**SUBDIVISION REVIEW SHEET****CASE NO.:** C8-2017-0154.01.2A**COMMISSION DATE:** May 3, 2022**SUBDIVISION NAME:** Interport Section 2C Final Plat**ADDRESS OF SUBDIVISION:** 3101 Fallwell Lane (East Highway 71 & Highway 130)**APPLICANT:** EP Austin Purchase Company  
Stoneridge Capital Partners, LTD  
Village Capital Corporation**AGENT:** Dunway/UDG  
(John Noell, P.E.)**ZONING:** LI-PDA**AREA:** 85.22 acres**LOTS:** 5**COUNTY:** Travis**DISTRICT:** 2**WATERSHED:** Onion Creek**JURISDICTION:** Full Purpose**DEPARTMENT COMMENTS:**

**CITY OF AUSTIN –DEVELOPMENT SERVICES DEPARTMENT  
SUBDIVISION APPLICATION – MASTER COMMENT REPORT**

CASE NUMBER: C8-2017-0154.01.2A  
 REVISION #: 00 UPDATE: U1  
 CASE MANAGER: Cesar Zavala PHONE #: 512-974-3404

PROJECT NAME: Interport 2 Section 2C Final Plat  
 LOCATION: 3101 FALLWELL LN

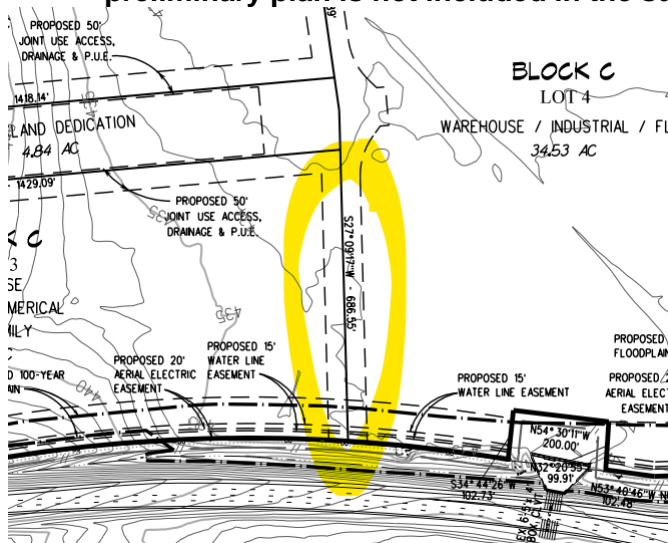
ATD 2. The layout of the proposed plat does not match the approved preliminary plan. Revise the layout to match the preliminary plan, or submit a revision to the preliminary plan. LDC 25-4-59, 25-4-61. All proposed joint use access easements included on the approved preliminary plan must be included in the final plat.

**U1: The joint use access easement area shown in the image below from the approved preliminary plan is not included in the submitted final plat. Please revise.**
